Access Compliance Report

Public Rights-of-Way

Intersection ID: 8751	Main Street: CENTRE_ST	Cross Street: ODUM_AV	Location: NW
ADA ID: B2FA00BE2DC8	Ramp Type: Perp	Initial Pass/Fail: Fail	Overall Compliance: No
Severity Score: 21.25			
Codes/Mitigation Info/Possible Solution		Field Measurements/Component Compliance

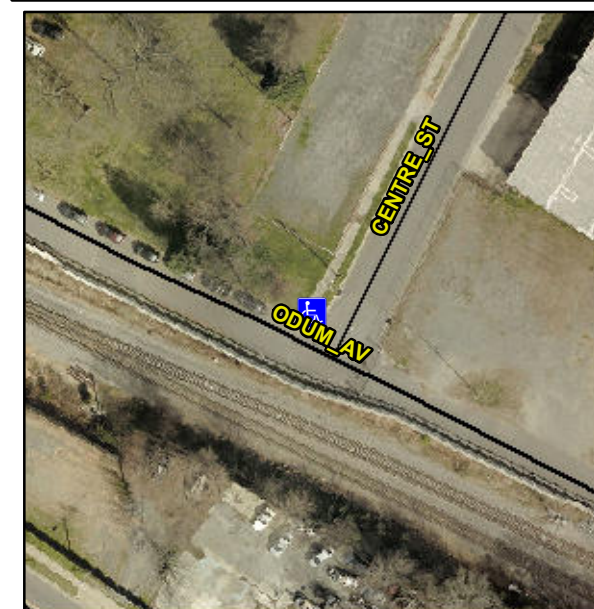
Not Found, R304.5.1, R304.5.3

Compliance	Description	Data	Compliance	Description	Data
N/A	Ramp Length (in)	49.0	Yes	Ramp Slope (%)	7.6
No	Ramp Width (in)	47.5	No	Ramp XSlope (%)	5.3
N/A	Flare Type LT	N/A	N/A	Flare Type RT	N/A
N/A	Flare Slope LT (%)	N/A	N/A	Flare Slope RT (%)	N/A
N/A	Flare Traversable LT?	N/A	N/A	Flare Traversable RT?	N/A
N/A	Landing Length (in)	N/A	N/A	DWS Provided?	N/A
N/A	Landing Width (in)	N/A	N/A	DWS Contrast?	N/A
N/A	Landing Slope (%)	N/A	N/A	DWS Length (in)	N/A
N/A	Landing X Slope (%)	N/A	N/A	DWS Full Width?	N/A
N/A	Landing Curb? (Y/N)	N/A	N/A	DWS Offset (in)	N/A
N/A	Shared Landing?	N/A			
N/A	Gutter Ponding?	N/A	N/A	Gutter Slope (%)	N/A
N/A	Gutter Lip Ht (in)	N/A	N/A	Gutter X Slope (%)	N/A
N/A	Painted X Walk1?	No	N/A	Painted X Walk2?	N/A
	X Walk 1 Direction	To S		X Walk 2 Direction	N/A
N/A	X Walk 1 Width (in)	N/A	N/A	X Walk 2 Width (in)	N/A
	X Walk 1 Slope (%)	1.6		X Walk 2 Slope (%)	N/A
	X Walk 1 X Slope (%)	3.3		X Walk 2 X Slope (%)	N/A

Remove & Replace Entire Ramp.
